TOWN OF WILTON

ADDENDUM NO. 1

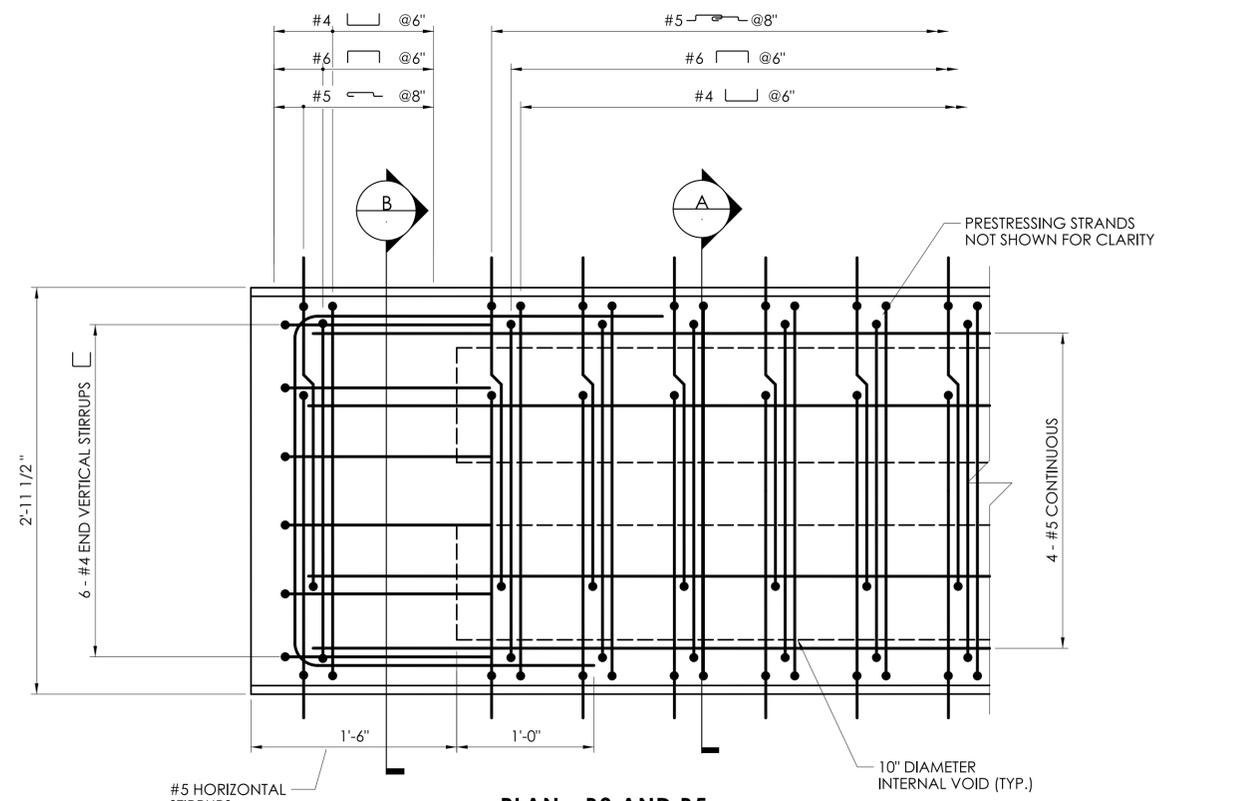
ADDENDUM NO. 1
